Final Development Plan Report – Comments Responses

For: *The Eastside Development and Hangar 2 at*
LEE'S SUMMIT MUNICIPAL AIRPORT
LEE'S SUMMIT, MO

CMT Responses to Planning and Development Review Comments

Application Name: LEE'S SUMMIT AIRPORT EASTSIDE DEVELOPMENT AND HANGAR 2

SHEET TITLE
WATER LINE PLAN & PROFILE - SHEET 1
C116
SHEET 027 OF 131

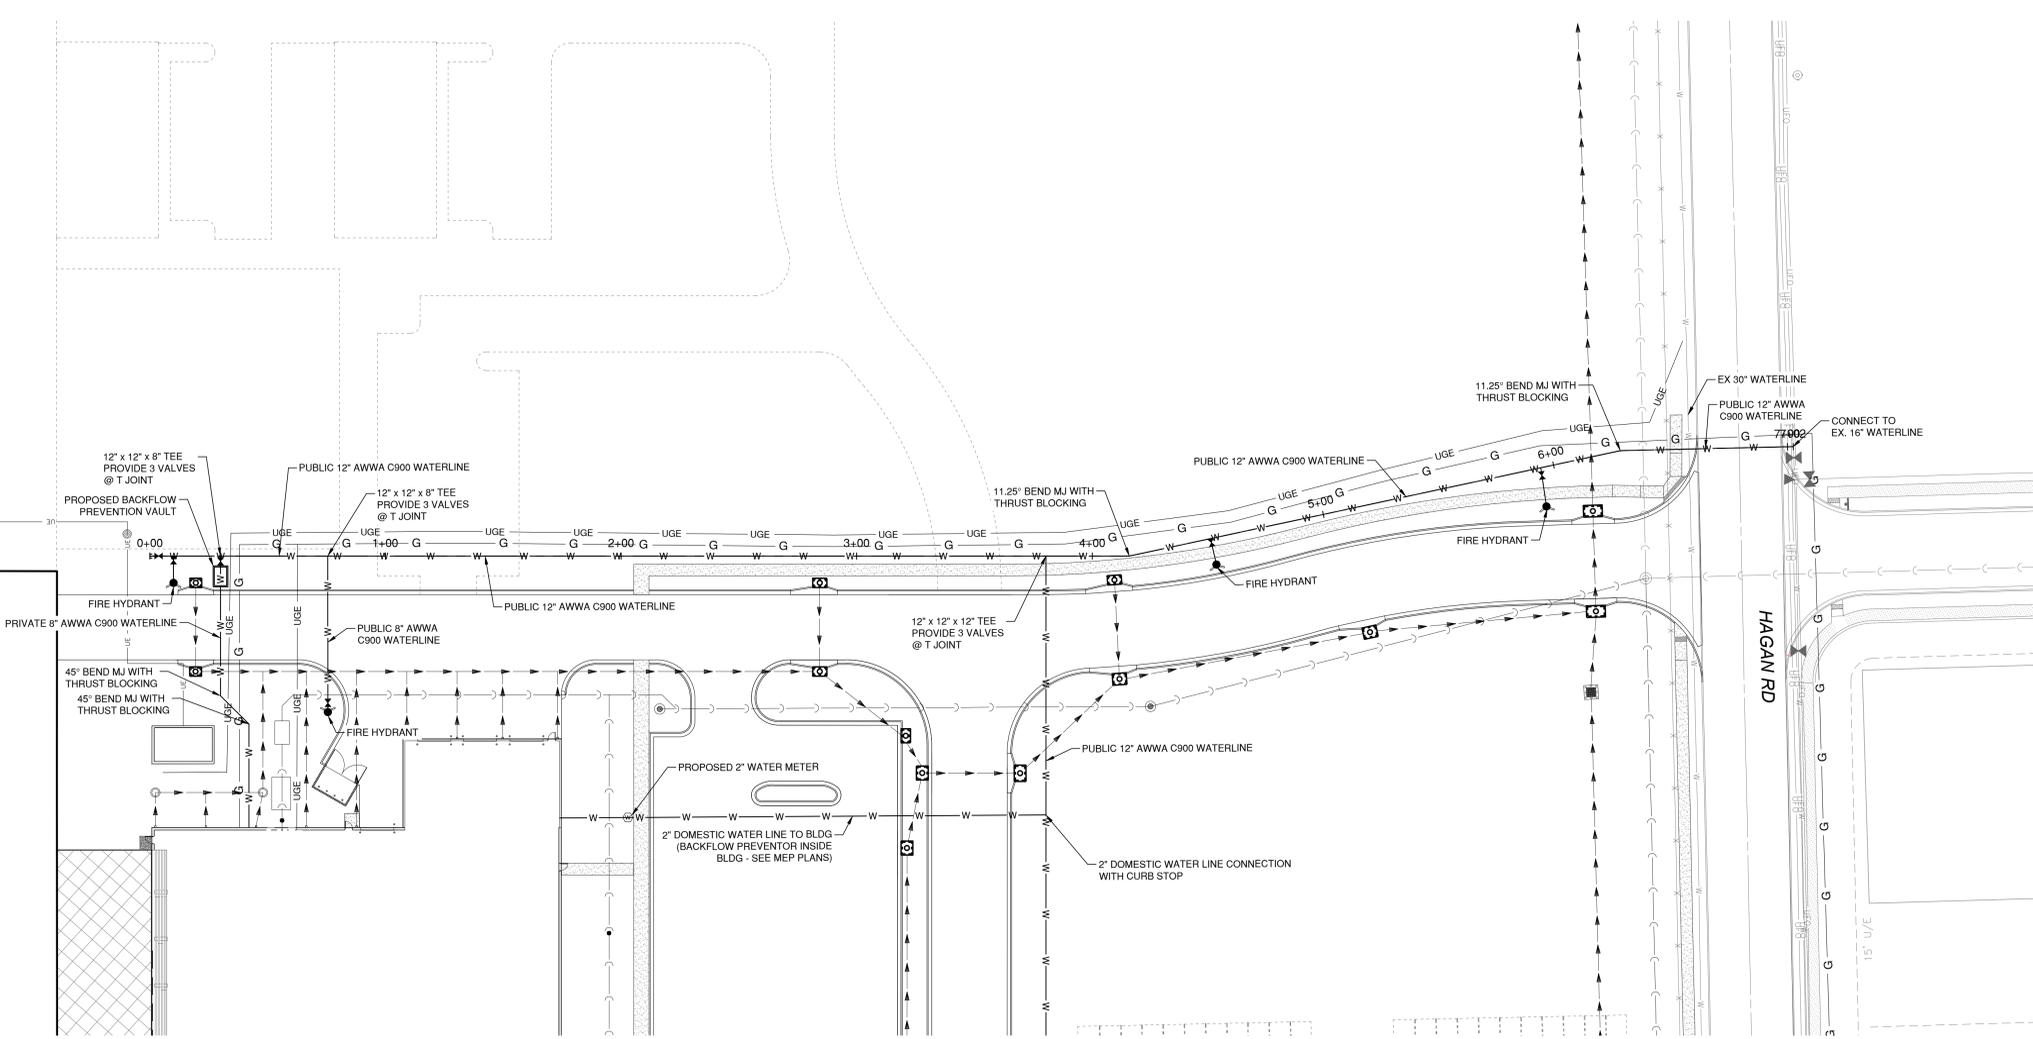
6. Please see the attached plans (above) for markups on the water main. In particular, Sheet C116 and C118. There are excessive depth issues that need to be addressed. Please be aware the City will allow the installation of the pipe beneath Hagan Rd. via open-cut, and this may help in the re-design. We will not, however, support a waiver to the depth issue to the extent shown. Seven (7) feet of depth is the maximum allowed for a water main, and there are instances where the water line is shown as deep as 15 feet. Please provide a re-design which addresses the depth issue to the maximum extent possible, including a re-design of storm lines if necessary.

Response: Waterline has been adjusted to minimize excessive depth

C118
SHEET 029 OF 131

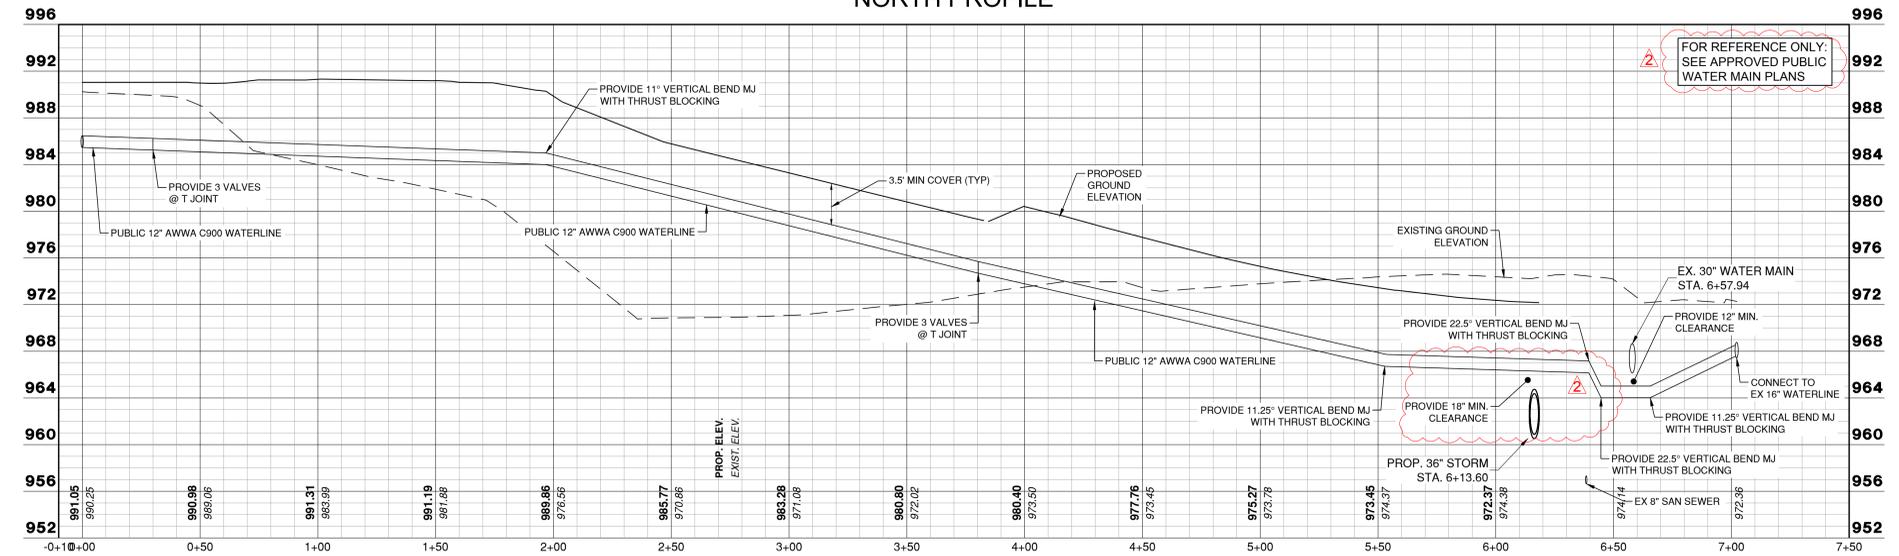
8. Please refer to comments 10 and 11 in the applicant letter dated Dec. 5, 2023. These comments relate to the 8 inch line in the northwest corner of the building. The termination of the public portion of the line in the northwest corner of the project should also be terminated with a fire hydrant near the northwest corner (either inline or offset), and the private 8 inch line serving the building should be installed via a tee to this line. A backflow vault also appears warranted outside the building. Please see the markup of Sheet C118 for a possible solution.

Response: A fire hydrant has been added in the northwest corner of the waterline, and a backflow vault has been added prior to building connection.
